DOCUMENT 00 91 01 –

ADDENDUM NO. 02

FOUNDATION PLAN

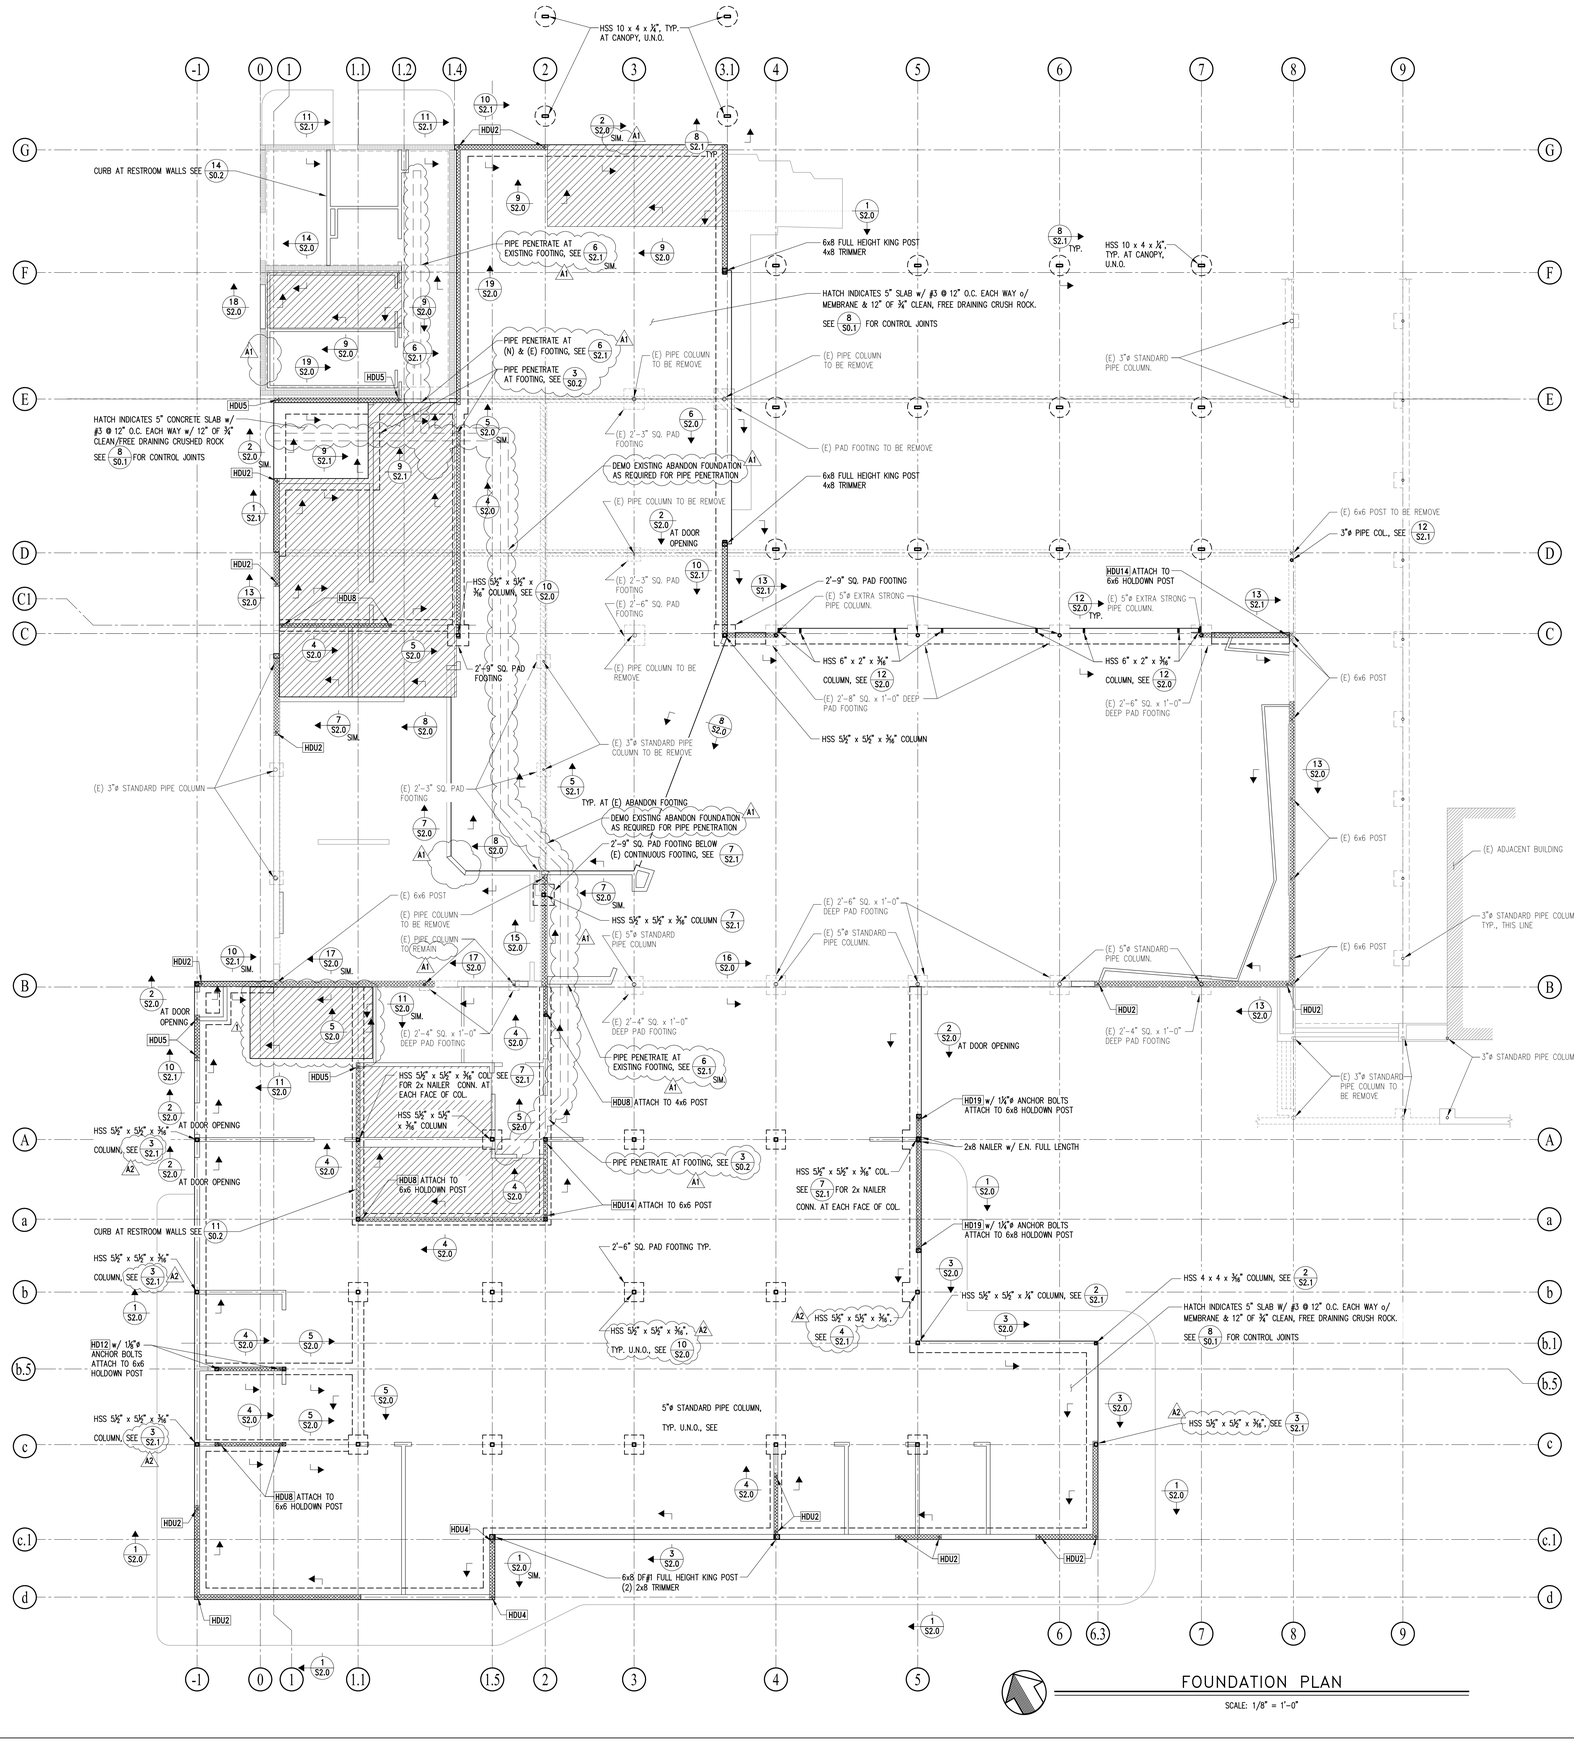
Question: Sheet S1.0 Foundation Plan - On grid line 1 at grid lines A, B & C calls for HHS column but there are no references to the base plate anchorage. Please confirm it is similar to detail 12 on S2.0.

Question: Sheet S1.0 Foundation Plan - On grid line 6.3 there is a call out for detail 3 on S2.0. Detail 3 refers to detail 1 on S2.0 which shows a raised curb of significant height with note "S.A.D." The corresponding details are 11 & 15 on A4.20, which shows a nominal 2" curb. Yet detail 2 on A8.41 shows an ~6" curb which seems to be corroborated by detail 1 on A8.30. Please confirm exterior wall curb heights.

Question: Sheet S1.0 Foundation Plan - Under Foundation Notes, #21 calls for "Re-Tightened" at Foundation Inspection. Did you mean "Rough Frame Inspection"?
Answer: **Yes, has been revised in Addendum #2.**

Answer: **Reference detail has been added to 3/S2.1 in Addendum #2.**

Answer: **See 7/S2.1 for similar; will add reference on sheet S1.0 in Addendum #2.**

S1.1

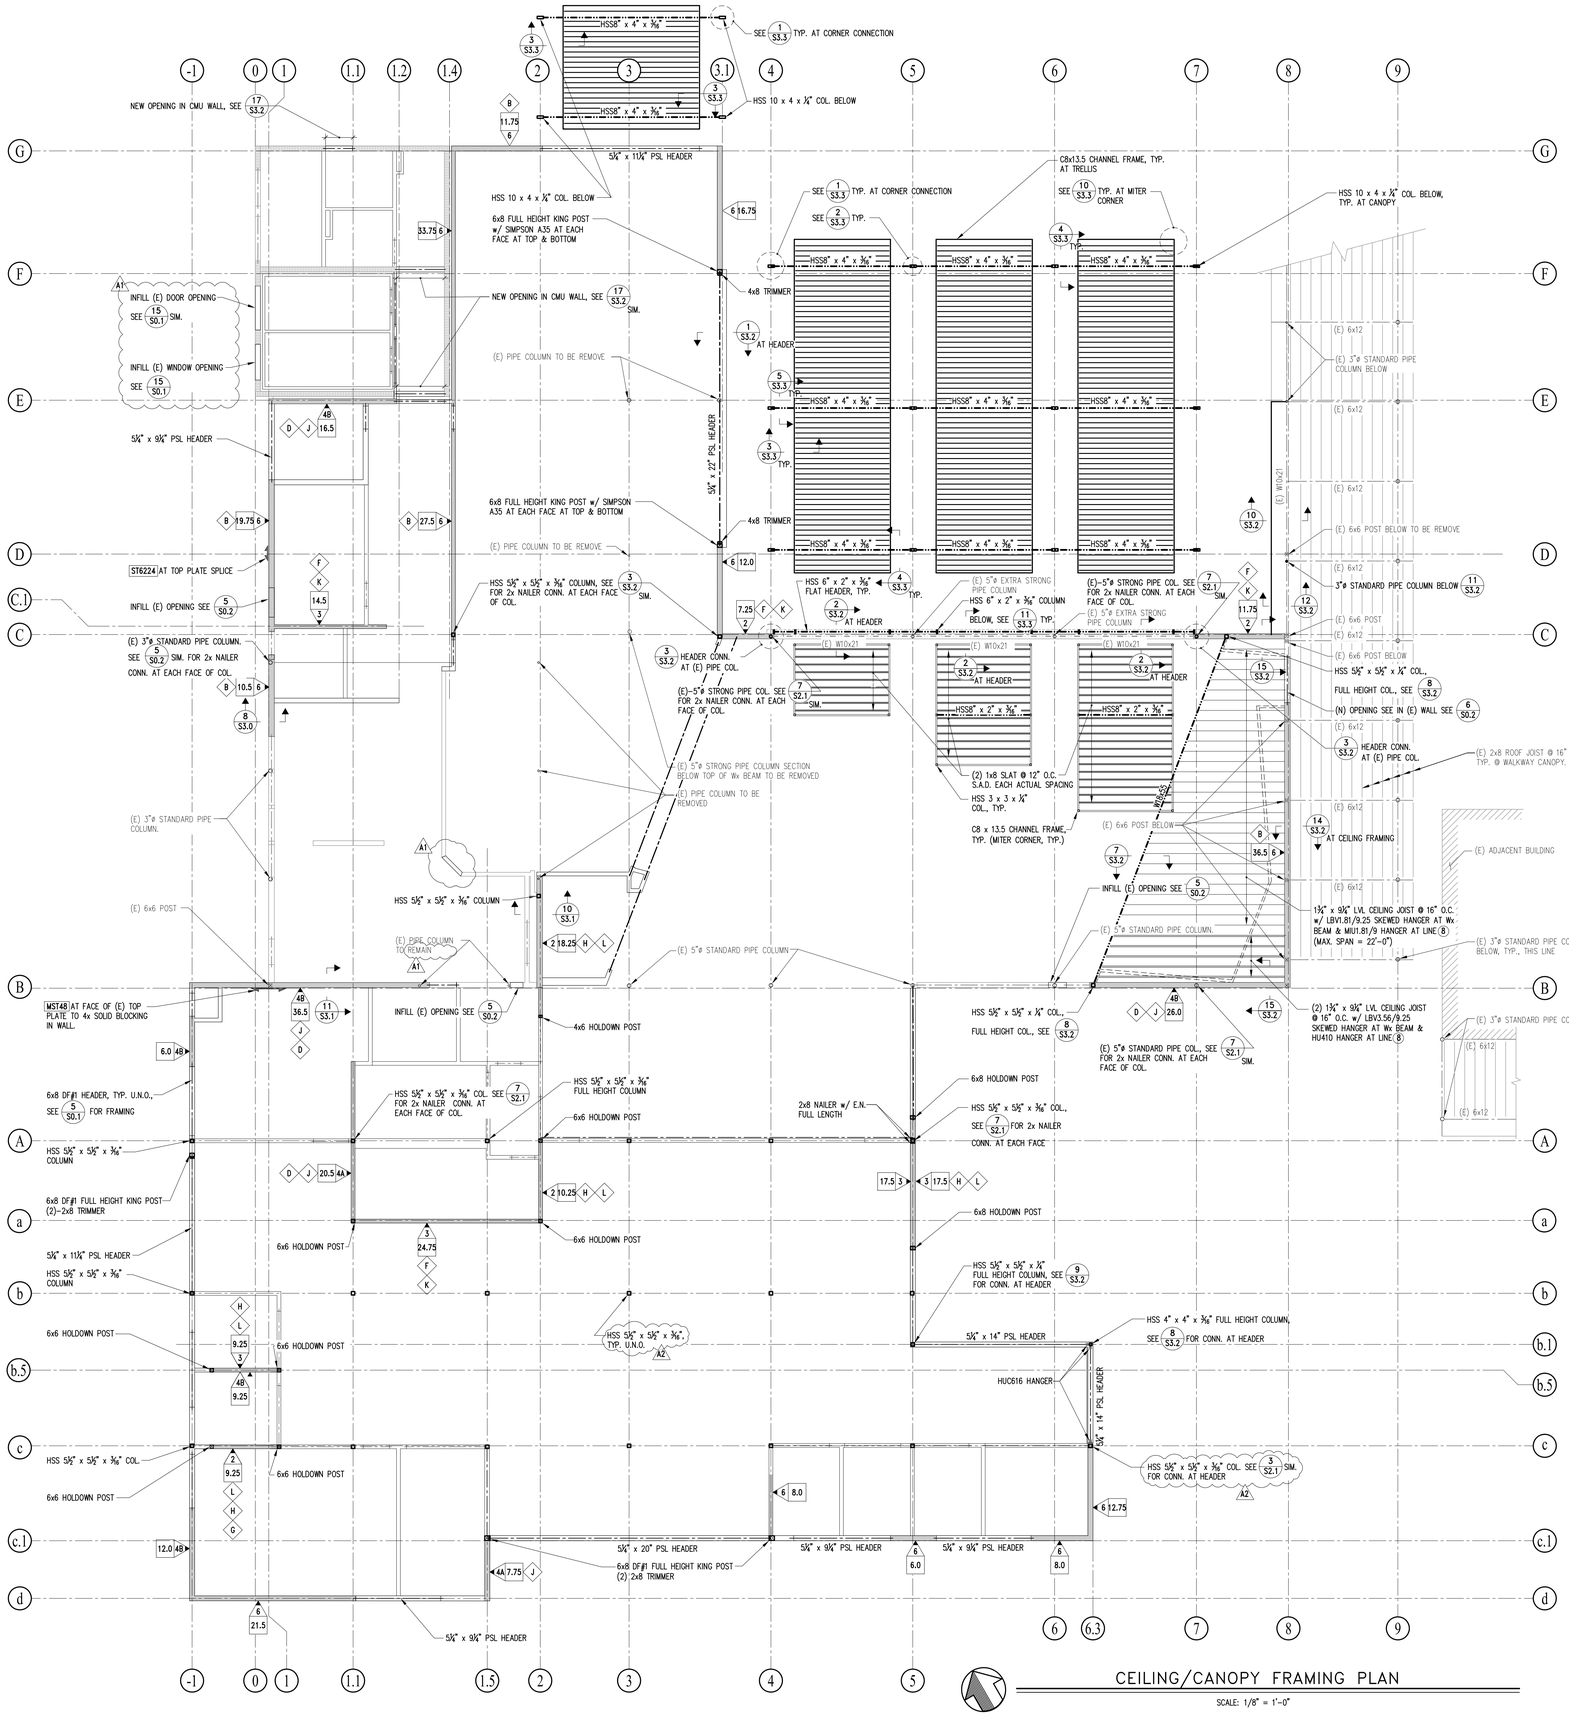
Sheet S1.1 – Ceiling Framing Plan

A. At grid lines 7.2/C & 6.3/B – revised reference detail from "8/S3.2" to "5/S3.2" and "full height" to "below".
B. At grid lines 3/b – revised pipe column to HSS square column.
C. At grid lines 6/c – added HSS square column and reference detail for connection at header.
D. Graphically changed pipe columns to HSS columns at grid lines A, b, & c

6 GAS ELECTRIC AC UNIT CONTROL DIAGRAM
NO SCALE

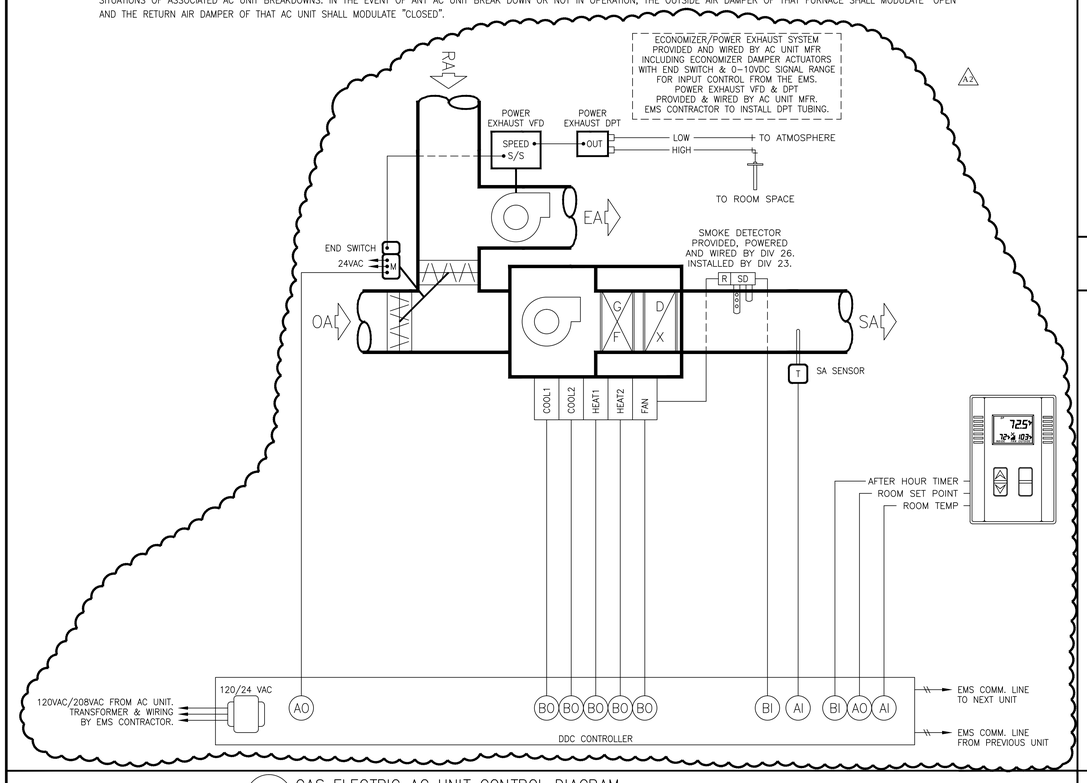
A. Detail 2: Revise title to "IDF ROOM FAN COIL UNIT (FCU/2-1)".
B. Detail 6: Revised detail to include speed control for power exhaust fan.

P2.1

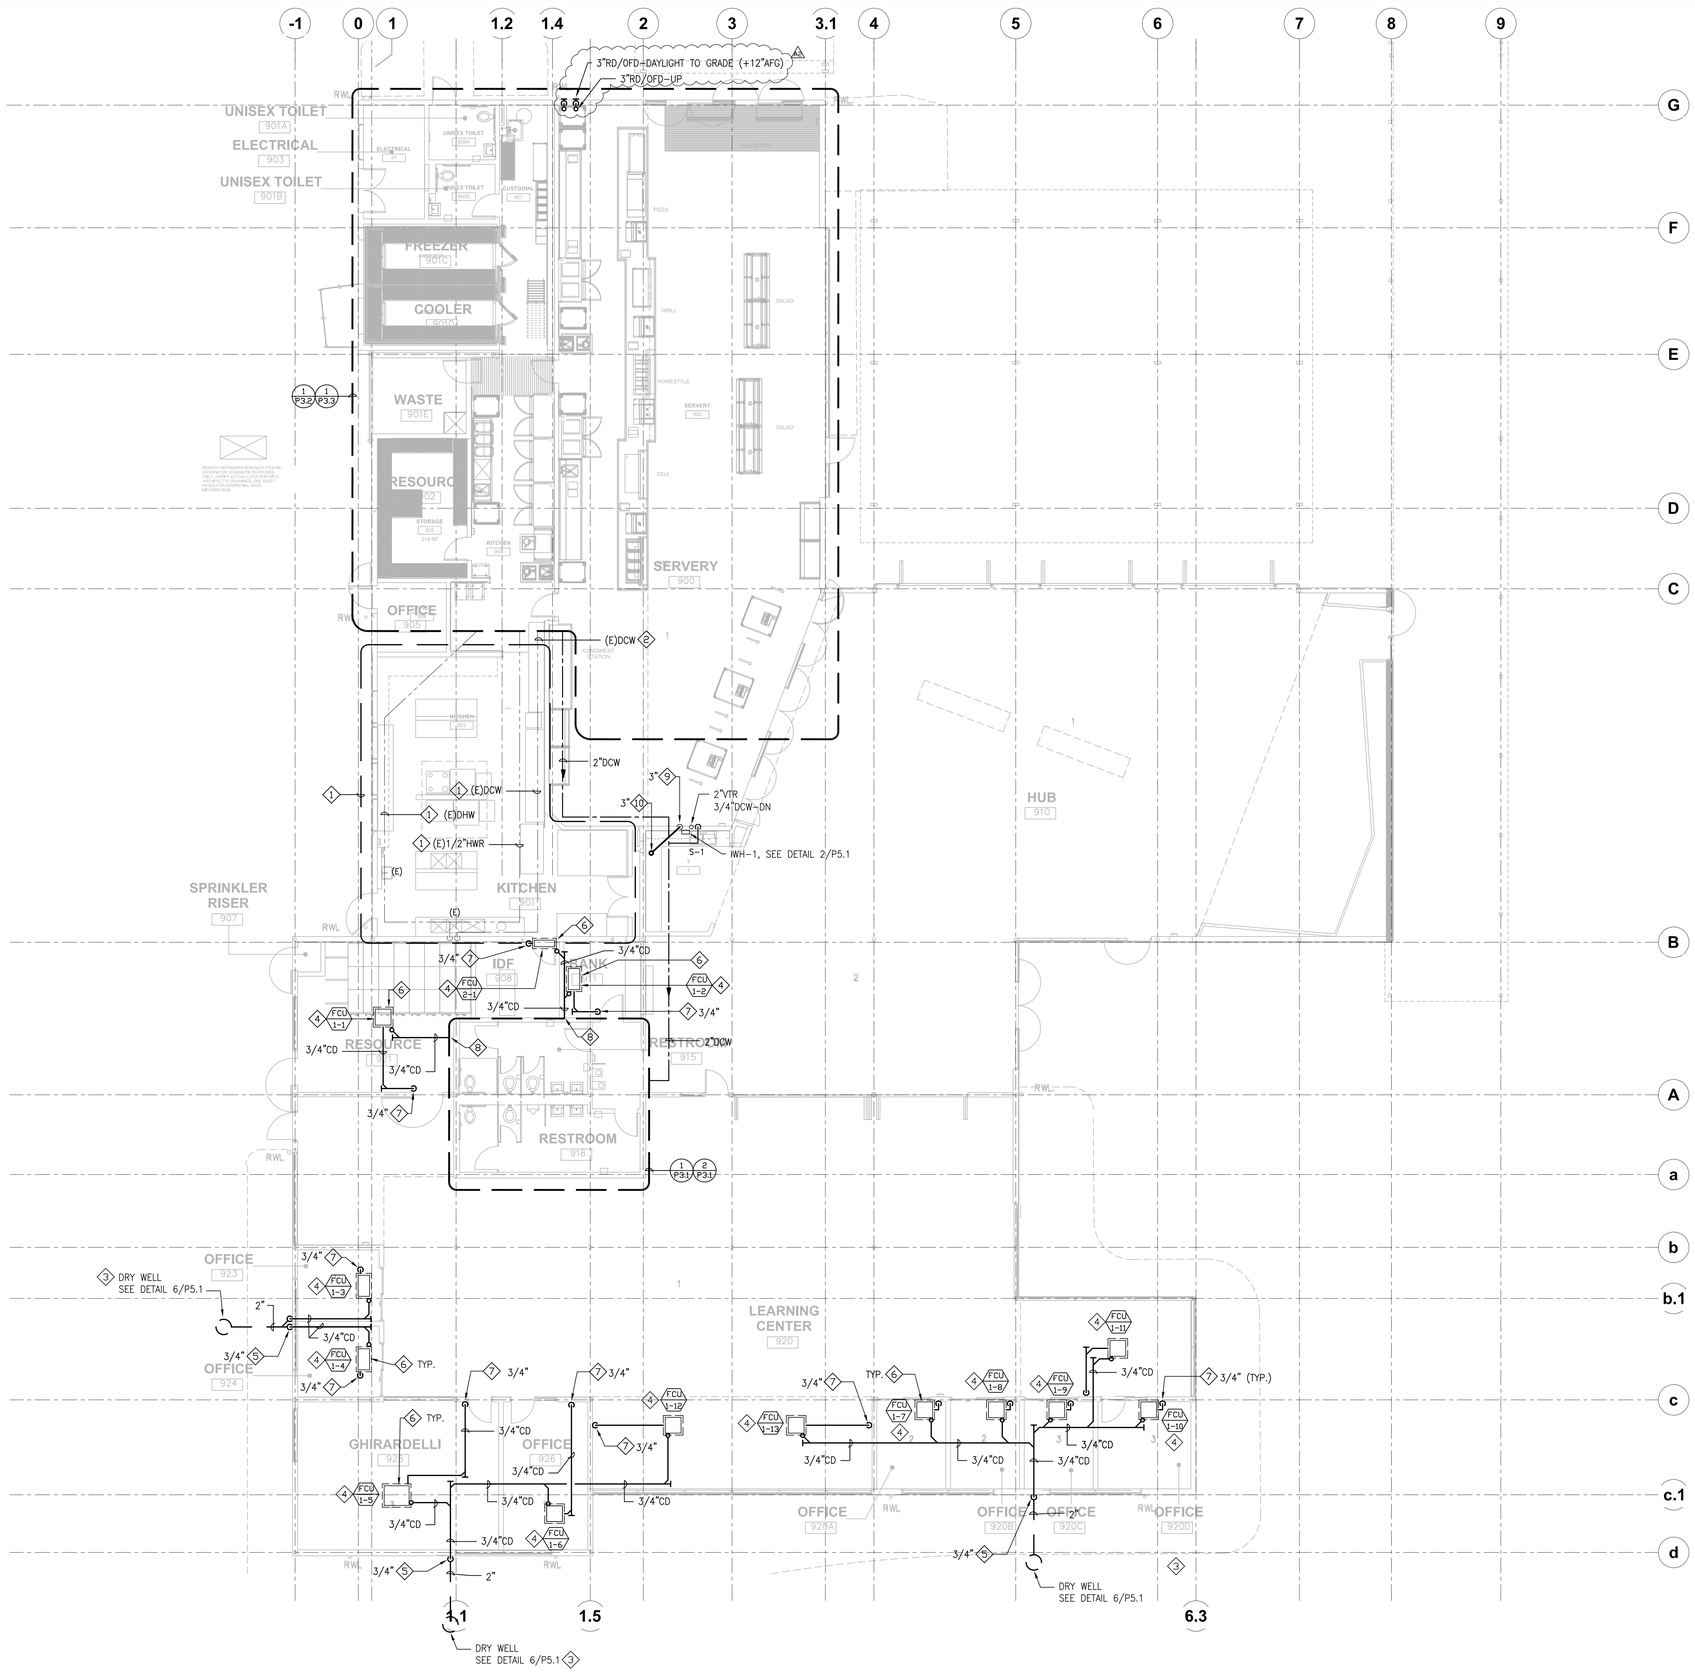
Sheet P2.1 - Plumbing Floor Plan
A. Revised roof drain and overflow drain at north end of kitchen, spilling to grade.
B. Remove three floor drains and relocated one floor drain to the new location indicated.
